**Environmental
Protection Agency**

May 3, 2011

RE: Wayne County
Baughman Twp.
BAU-TR-299-1.39 (Huprick Road)
Storm Water Construction

Fig 1 & 2. Storm drain inlet protection requires repair. In the photo on the left, a hole has developed in the geotextile allowing sediment-laden runoff to directly enter the catch basin. In the photo on the right, the geotextile has been lifted, limiting the effectiveness of this control measure.

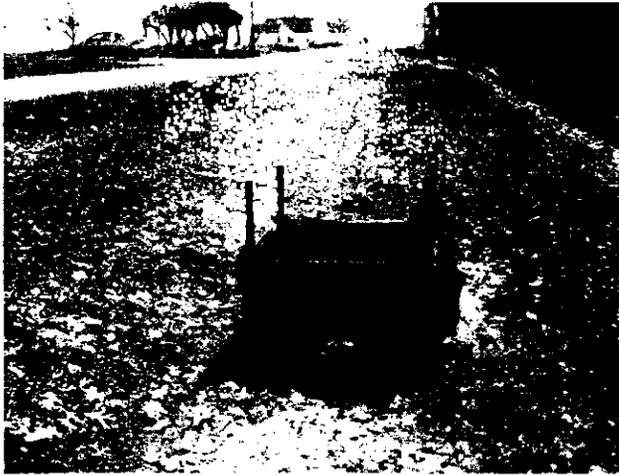
- Inlet protection around catch basins requires repair or replacement. Holes were observed in the geotextile around certain inlets and the geotextile was not trenched and backfilled around other inlets. Either condition prevents runoff from ponding around the inlet so that sediment can settle. Please make repairs or replace the geotextile, as appropriate.
- Perimeter silt fence is in need of repair at the back of the cul-de-sac and in the vicinity of STA 80+00. The silt fence in these locations is down and must be re-erected or better supported to withstand flow. Please make the appropriate repairs.
